Memorandum

From: Jim Strozier, Consensus Planning, Inc.

Date: July 19, 2023

Re: *PR-2022-007063, SI-2023-01044 DFT PV Trails/La Terra – DFT Comments and Responses*

Exhibit 15, Significant Rock Outcroppings
(Volcano Trails SDP – August 2011)

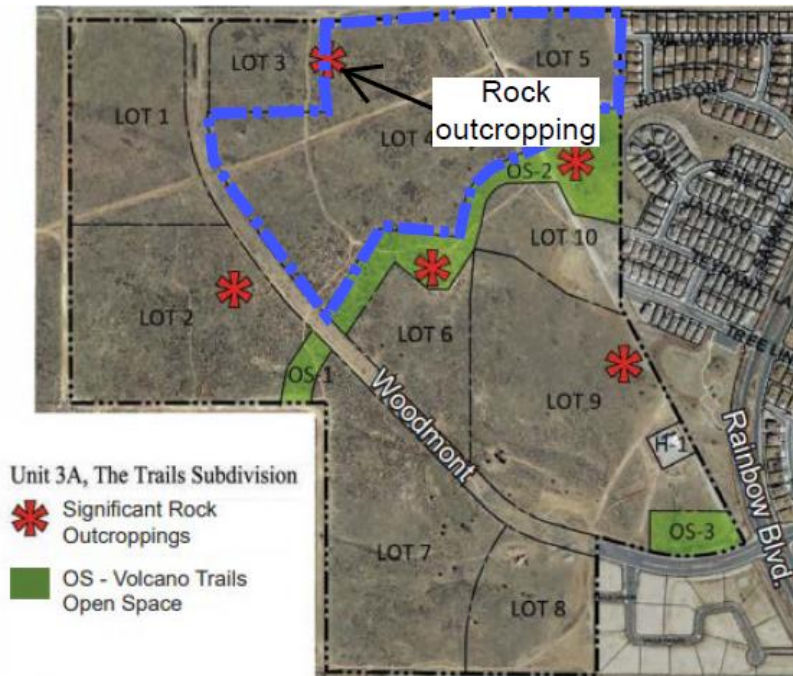
One rock outcropping had been identified on the site. Per IDO Bedrock or other stratum a minimum of 6 feet high on its steepest side as measured from the adjacent 10 percent slope line and in excess of 500 square feet in surface area, is considered a rock outcropping. Please identify all other Rock Outcroppings that exist on the subject property and provide an overlay of their current locations on the site plan.

Applicant Response: *Post DFT meeting, members of the Project Team conducted an additional site visit to locate and evaluate the other (minor) rock outcroppings on the property. The Sensitive Lands Analysis has been updated and an exhibit was created showing the locations relative to the Site Plan. Due to significant constraints in these areas relative to site grading, utility construction, etc., there are no changes proposed as a result of the minor rock outcroppings.*
